Natural Features Protection

Review Board

City of Kalamazoo

1. NFP Site Plan for the Friendship Village Campus Repositioning & Skilled Additions project located at 1400 and 1402 N. Drake Road
2. NFP Site Plan for Site Improvements and Building Addition at 3301 Tech Circle Drive
3. 2025 Natural Features Protection Board Meeting Schedule (**Action: Motion to adopt 2025 Meeting Schedule**)

Overall
Landscape
Plan

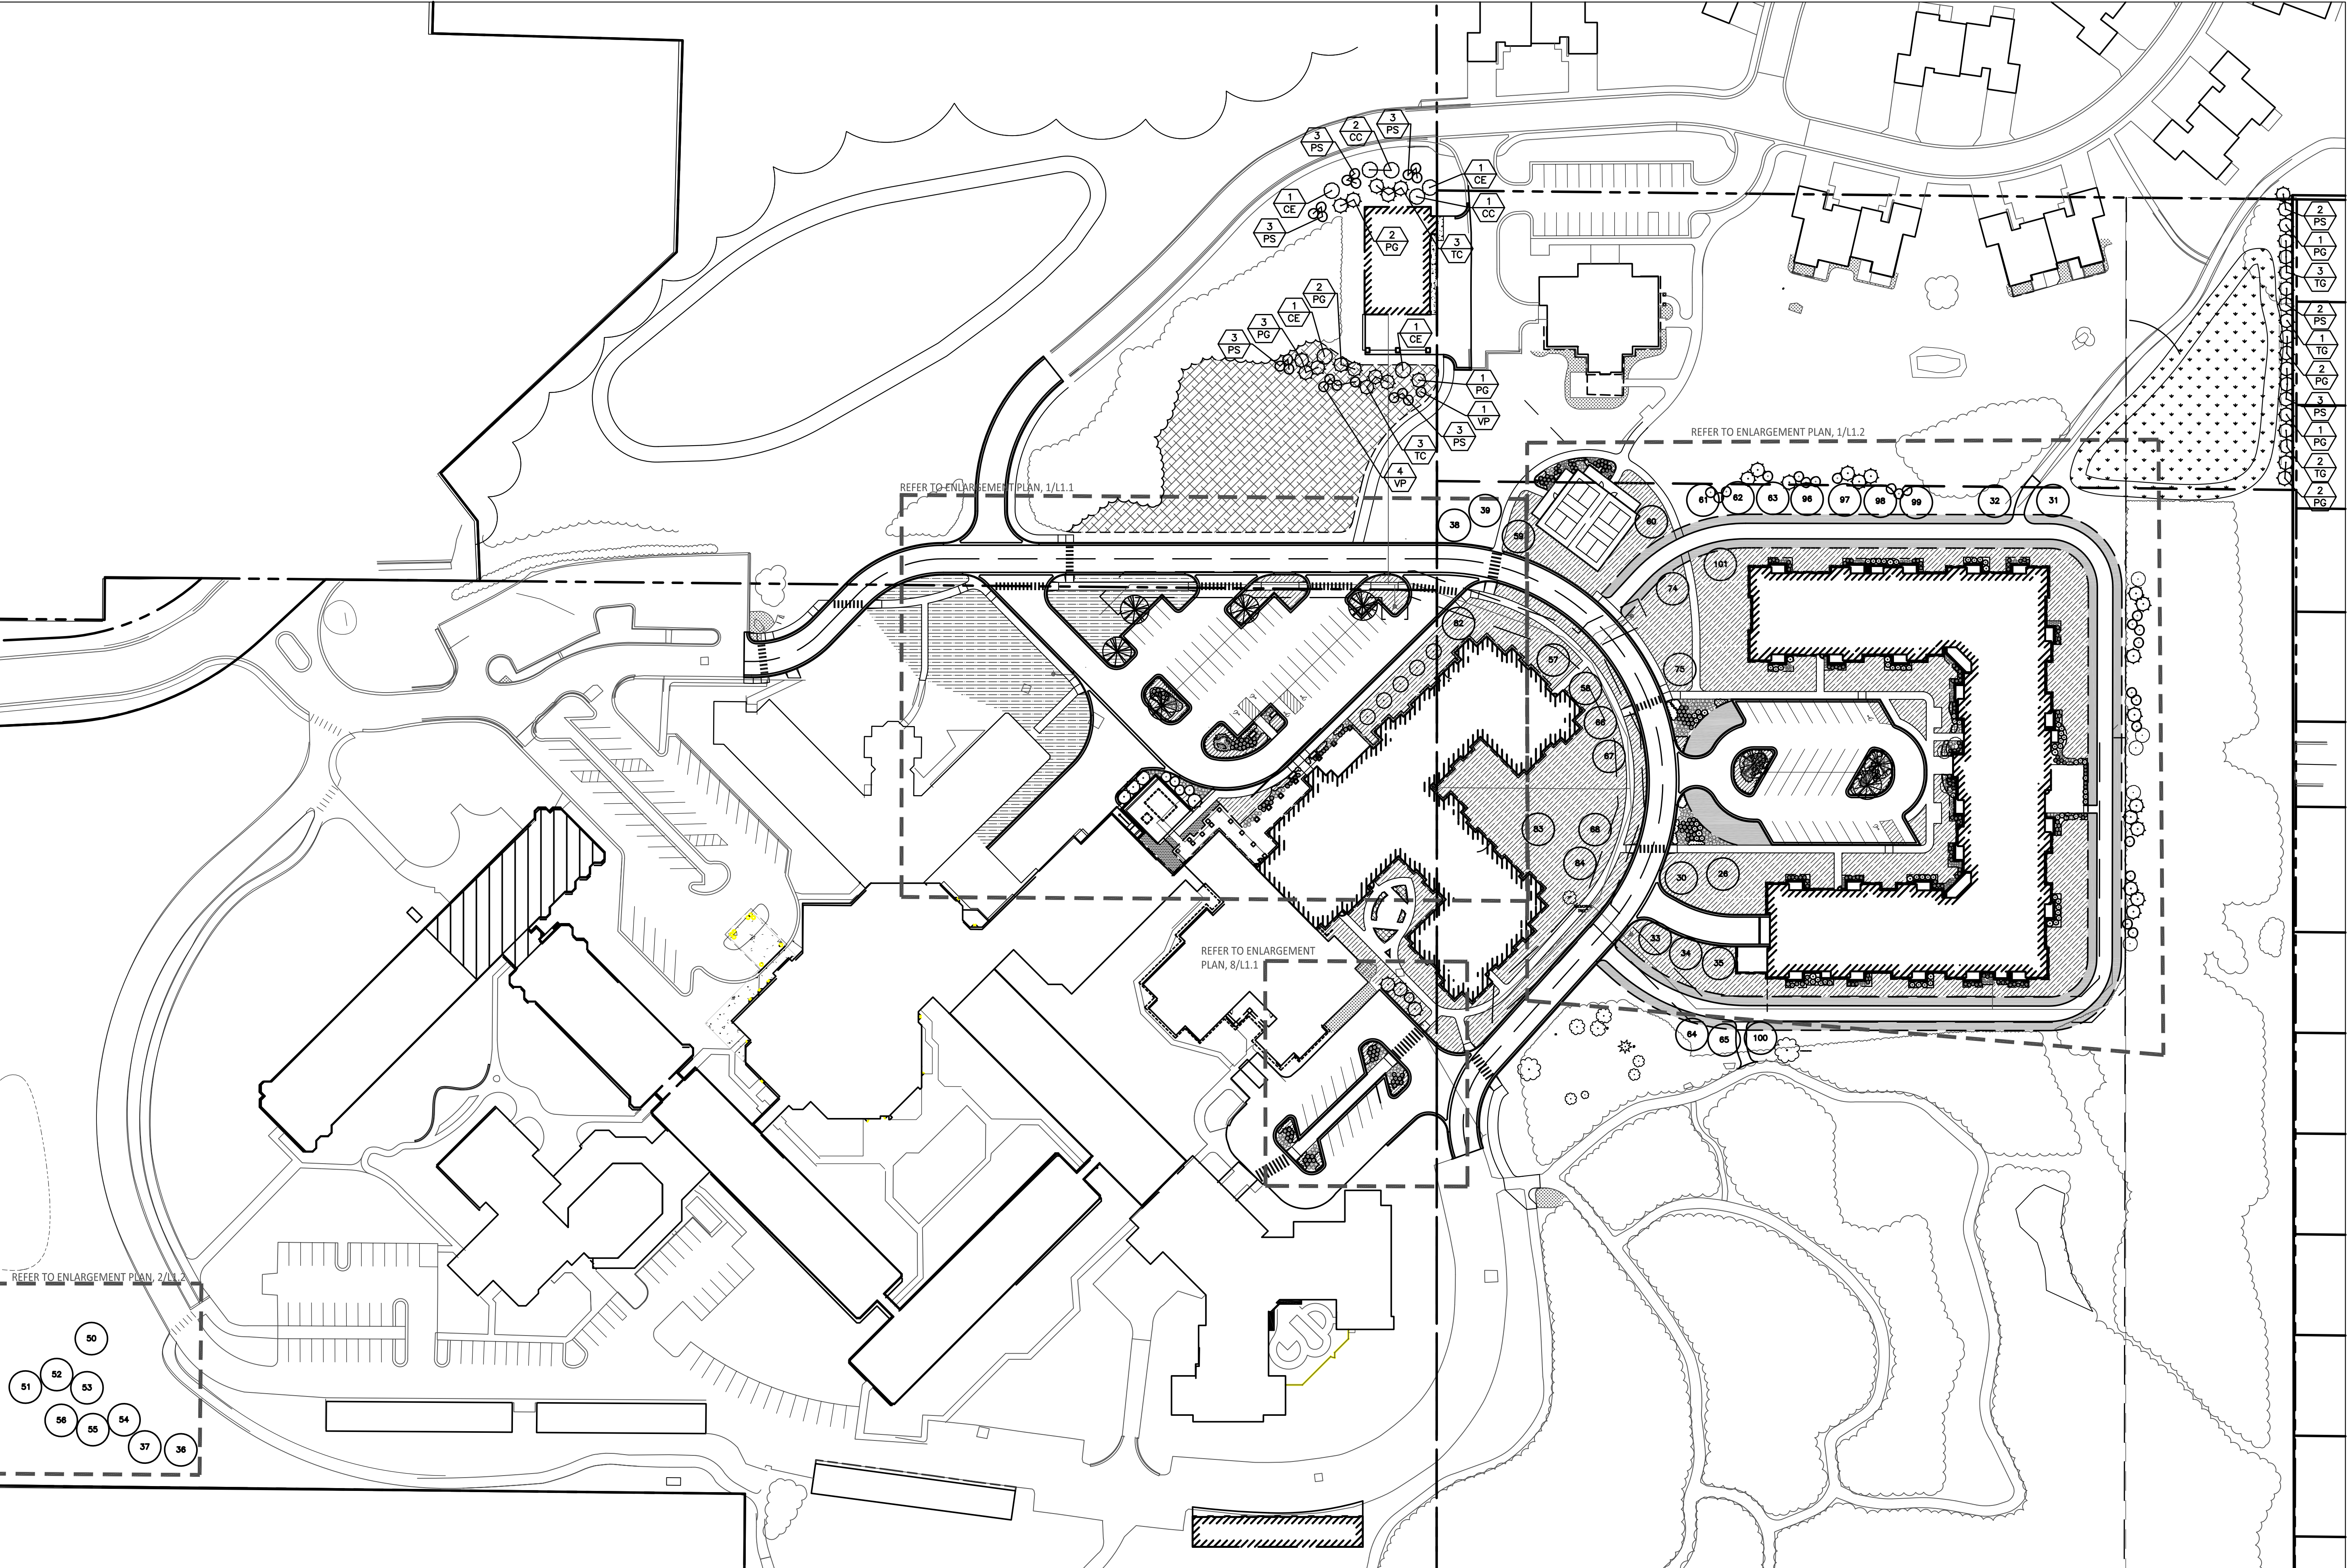
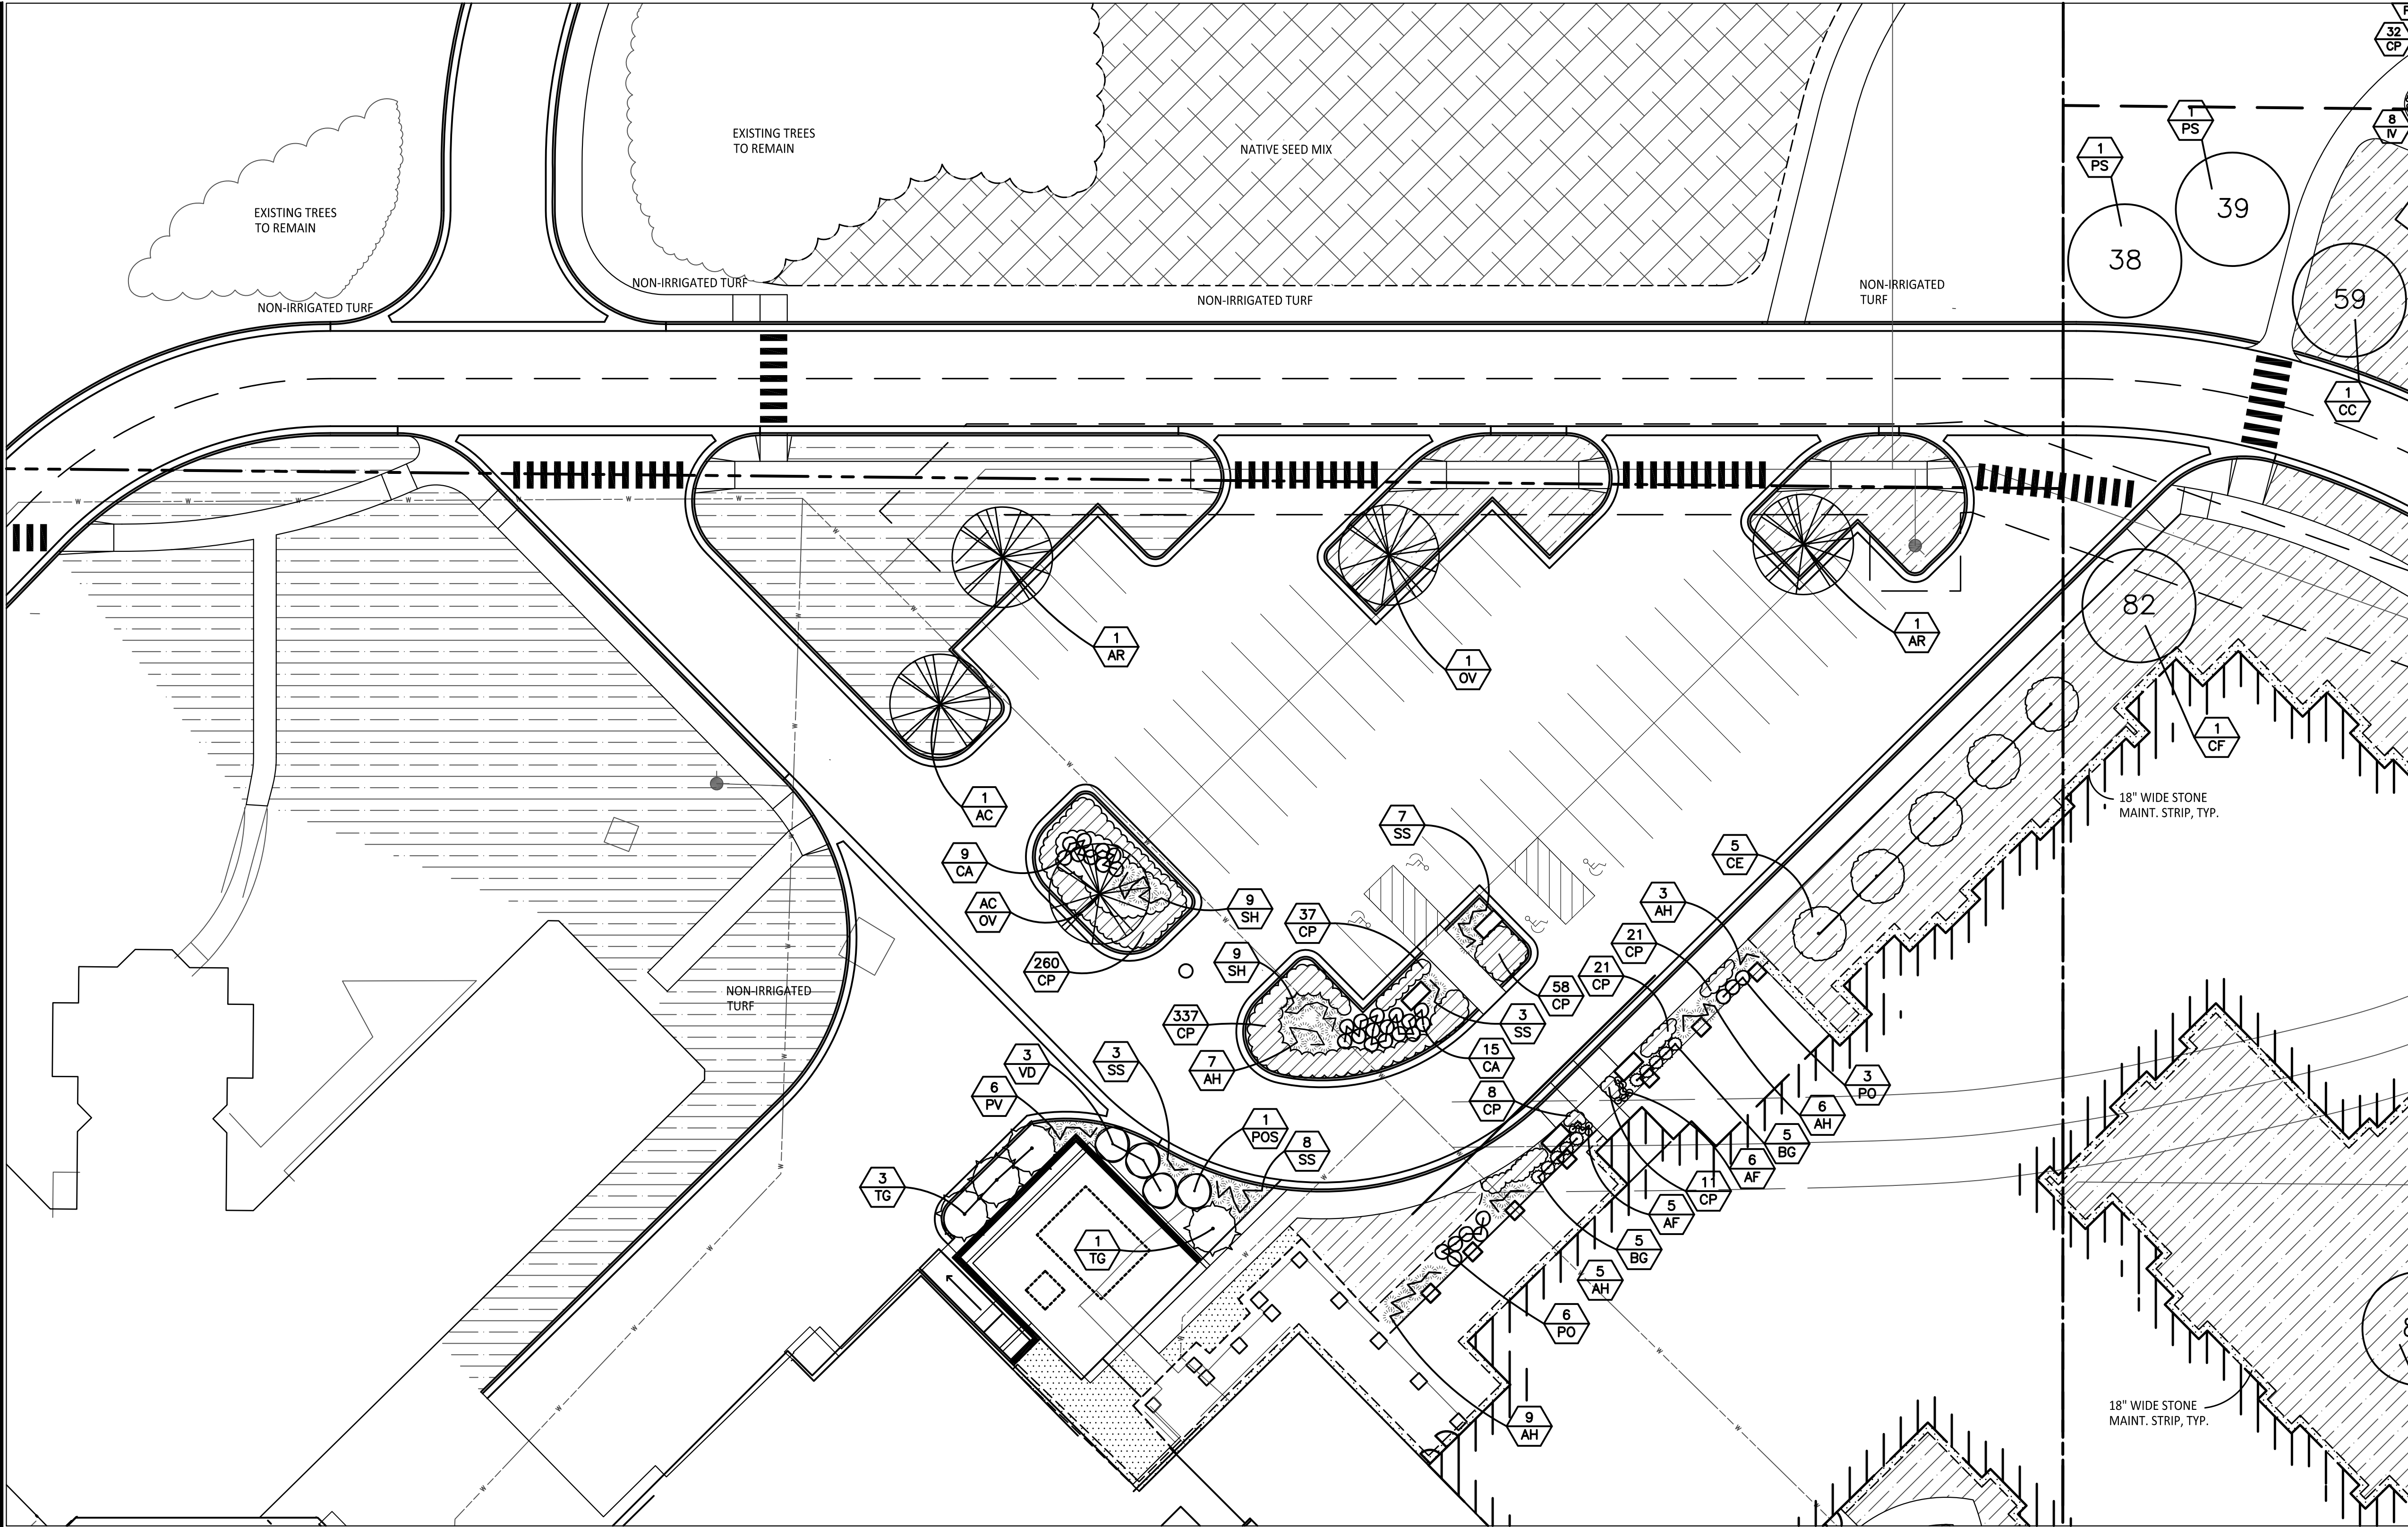
Director Fuller: There were a couple of non-native species on the landscape plan and with the NFP they are required to be native? Are those good zoning trees?

Director Fuller: The understanding is that NFP and Landscaping plan should all be native species.

Rachel: Questioning further that on any plantings around a patio area or similar have to be native whether or not it's related to Woodlands plant protected trees?

Nolan: NFP board can approve a planting list even if there are non-natives on the list, the preliminary review of some of the non-natives on the zoning list did not come up as invasive so they could potentially be non-native and non-invasive species. For final approval, the board could suggest alternatives or if NFP is ok with the species as they are in the plan.

Rachel: For instance, perennials and grasses, ornamental grasses are easy to do native and trees are fairly easy to do native unless there is specific. The issue is the shrubs to plant native, they are large and at entry ways they makes it difficult.

Martin: There is a preference for native species but if something better fits the needs there is a prohibited planting species list. The case can be made for why and what you want to plant and use. Native species to fit there needs?

Nolan: He will check the plan and code and give an update.
